TO: Mountain Village Design Review Board
FROM: Amy Ward, Planner
FOR: Design Review Board Public Hearing; May 6, 2021
DATE: April 26, 2021
RE: Staff Memo – Initial Architecture and Site Review (IASR) Lot 628-H, 116 Double Eagle Way

APPLICATION OVERVIEW: New Single-Family Home on Lot 628-H

A3.2
ENTRY MONUMENT

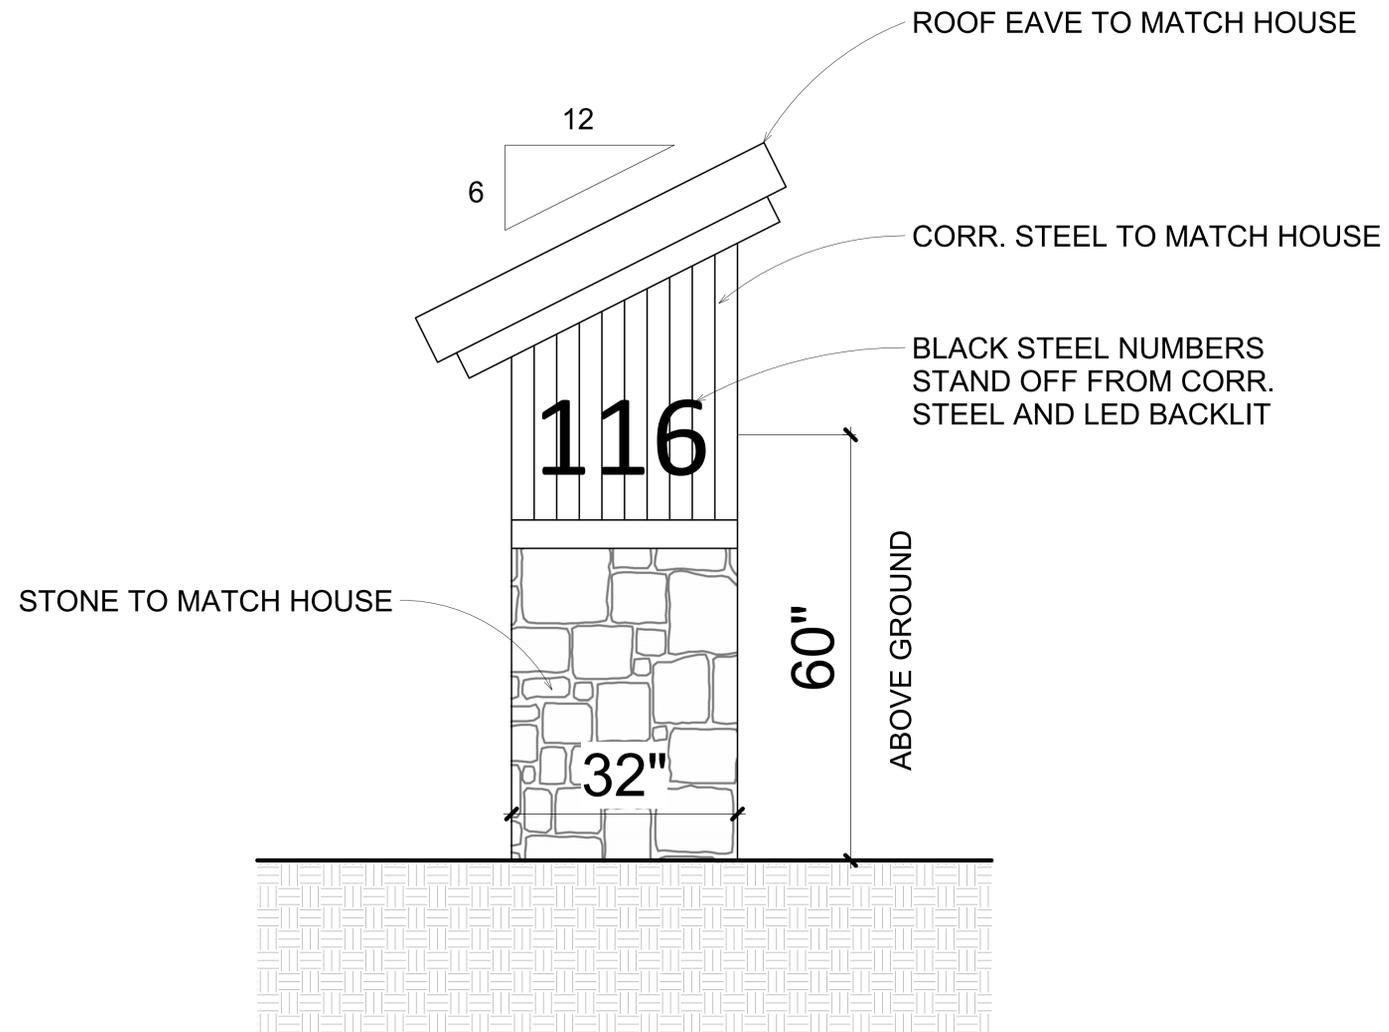
Staff: The address marker is located within the road right of way to the west of the driveway. This location is appropriate due to the distance between edge of paved surface and the lot line. A right of way encroachment agreement will be required. Not enough information is provided to understand whether the dimensions of the monument meet those required by the CDC. The numbers are indicated as black steel, but need to have a reflective coating applied in case of power outage. LED lighting is indicated, however is shown as back-lit. Prior to FAR the applicant shall revise the address monument to meet all requirements of the CDC.

- 3) Prior to final review, the applicant shall revise the address monument to ensure compliance with all regulations of the CDC.
- 4) Prior to final review, the applicant shall revise the lighting plan to demonstrate that all fixtures meet the lighting requirements of the CDC and shall provide a photometric study.

A3.3
SIDING AND HEIGHT CALCULATIONS

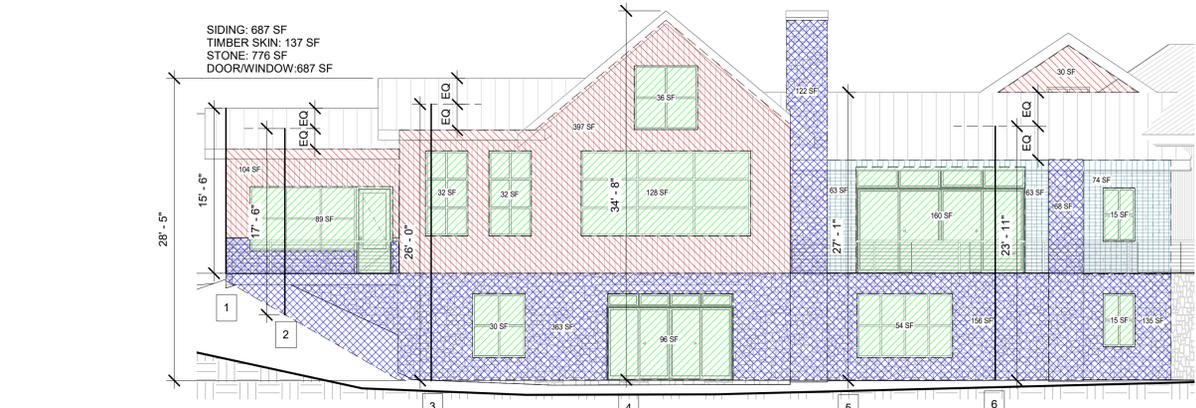
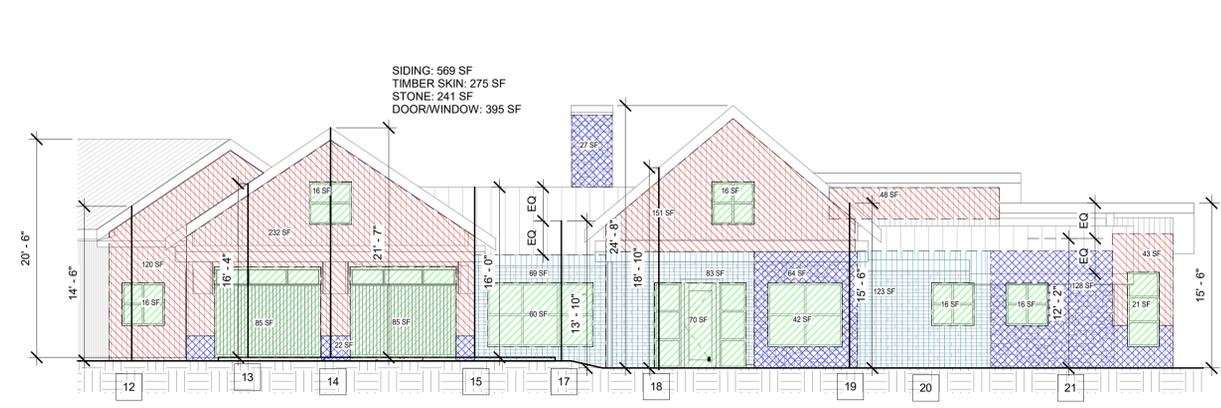
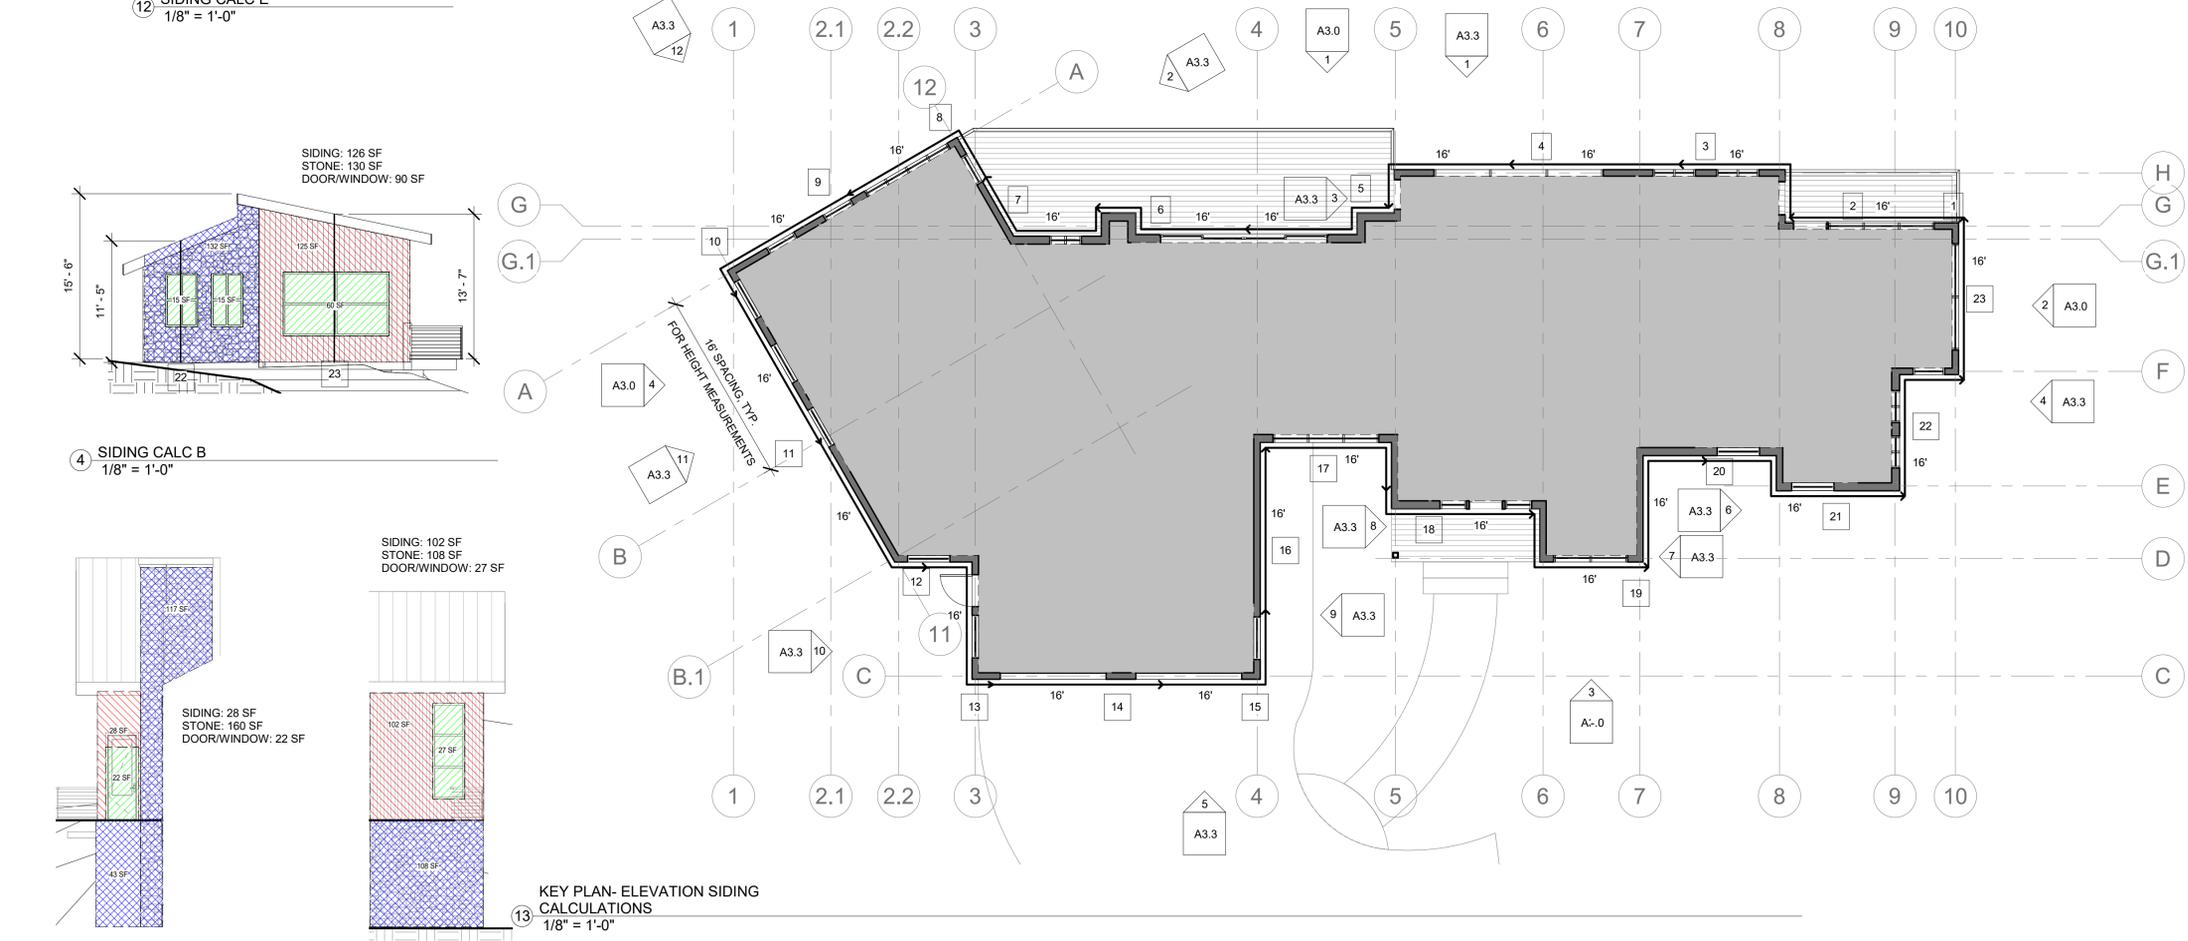
Staff: Staff has determined that the primary roof form for this home is a gable and therefore granted a maximum height of 40 feet. The applicant has indicated a maximum height of 34' 8", which meets the max height allowable per the CDC. The applicant has provided an

average height of 13.7' however staff believes this is an error and estimates the average height at just over 19'. The applicant should revise the drawings to clearly indicate average height and should include a parallel plane analysis demonstrating overall height compliance for final review.

- 5) Prior to final review, applicant shall revise the roof plan to include snow fencing.
- 6) Prior to final review the applicant shall revise the drawings to clearly demonstrate average height compliance and provide a parallel plane analysis to further illustrate height compliance.

E1
 ELECTRICAL - PLANS AND ELEVATIONS

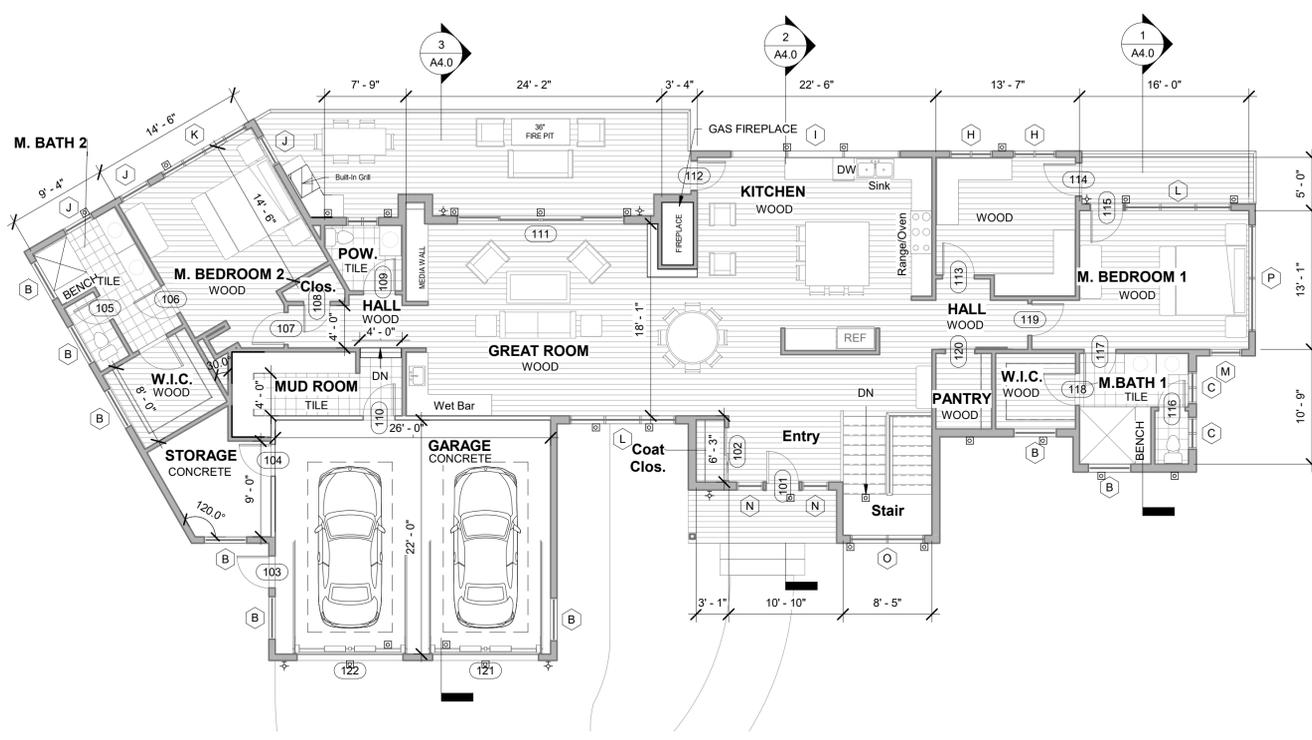
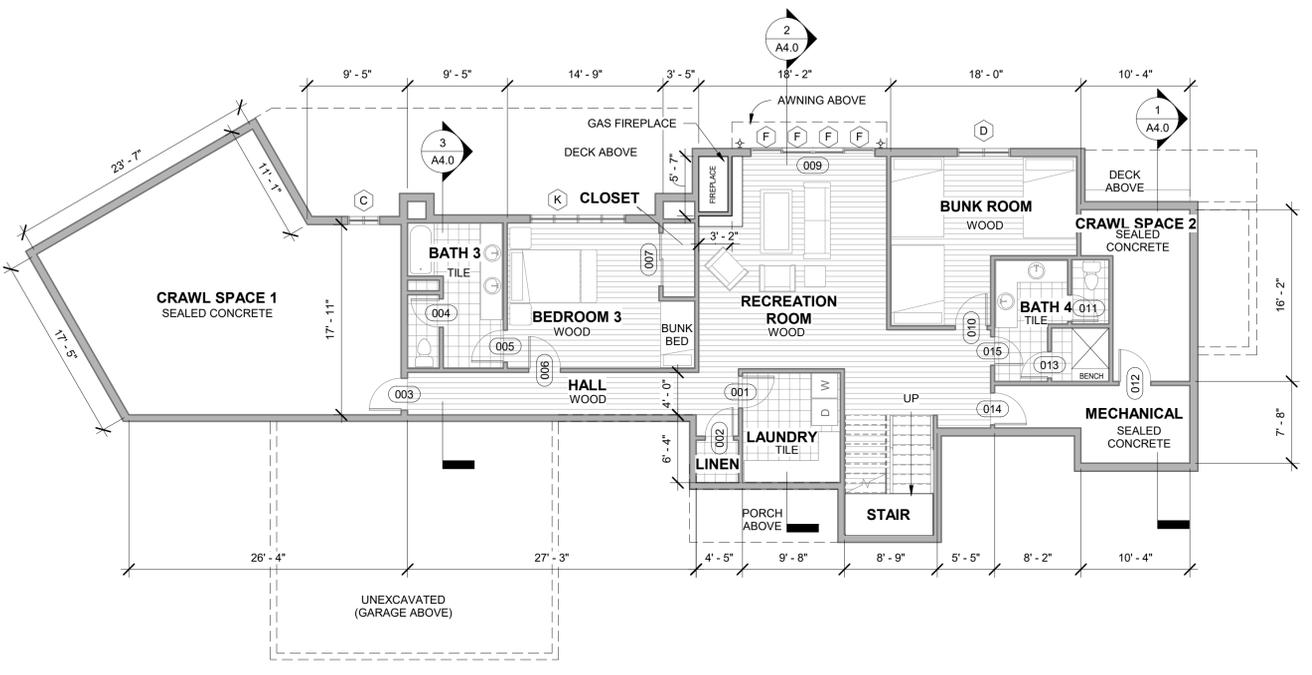
Staff: The applicant has provided a preliminary exterior lighting plan with fixture specifications. However, no key was provided to correlate the fixtures to the marked locations. The recessed light (fixture b) indicated appears to exceed the maximum lumens allowable. Fixture a appears to meet the regulations of the CDC. No photometric study was provided, but is required due to the square footage of the home. This plan shall be revised to address all CDC regulations prior to FAR.
